ADDENDUM NO. 1

TO: PLANS AND SPECIFICATIONS FOR THE STATE OF MISSOURI

Improvements to HVAC
Broadway State Office Building
Jefferson City, MO
PROJECT NO.: O2324-01

SHEET TITLE:
**ENLARGED PENTHOUSE
ELECTRICAL PLAN**

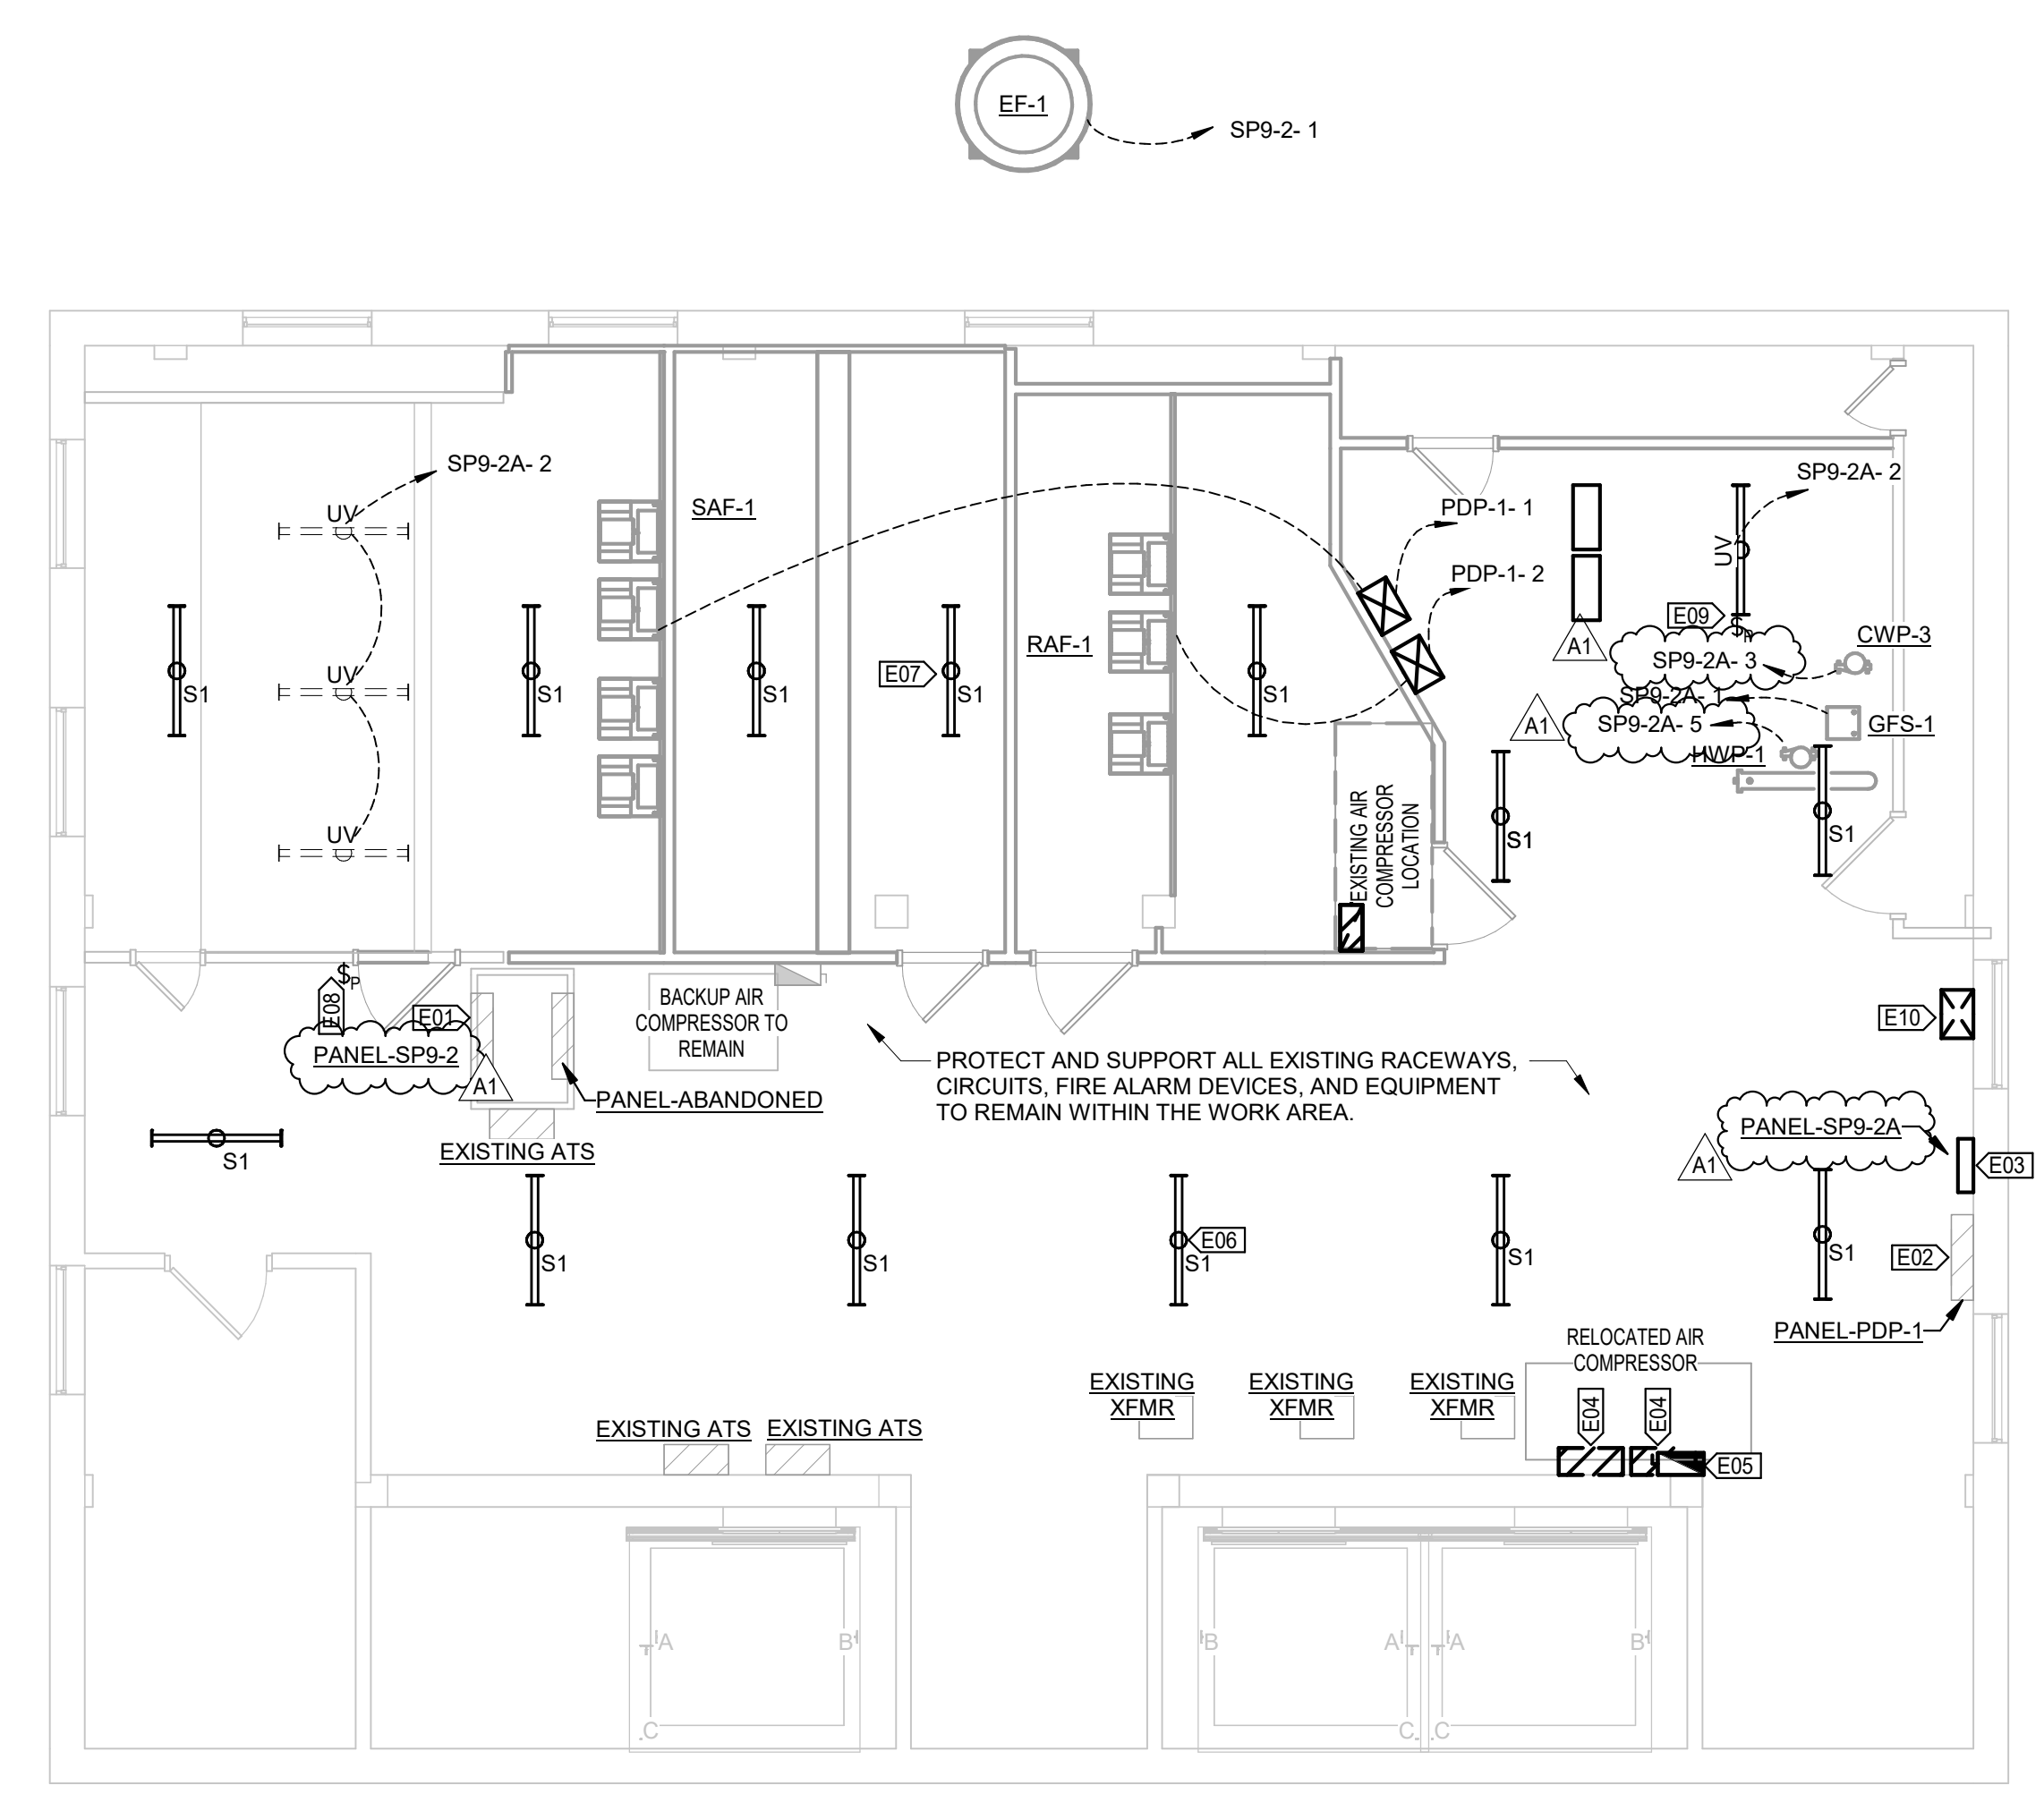
5. Sheet E201 – Enlarged Penthouse Electrical Plan
 - a. Revise panel names of SP9-1 AND SP9-1A to SP9-2 and SP9-2A respectively to match existing panel labels.

- b. Revise circuits to pumps CWP-3 and HWP-1 from three phase to single phase.
 - c. Revise keynote E01 to reference panels SP9-2 and SP9-2A in lieu of SP9-1 and SP9-1A as noted above.

- d. Revise keynote E02 as follows:
“EXISTING PANEL PDP-1 IS EATON MODEL PRL4F POW-R-LINE C.
REPLACE EXISTING 200A SWITCH WITH 125A SWITCH TO FEED RAF-1.
REPLACE EXISTING 200A SWITCH WITH 175A SWITCH TO POWER SAF-1.”

- e. Revise keynote E03 to reference panel SP9-2A in lieu of SP9-1A as noted above.
 - f. Add panel schedule for panel SP9-2A.
 - g. See revised Sheet E201, attached.
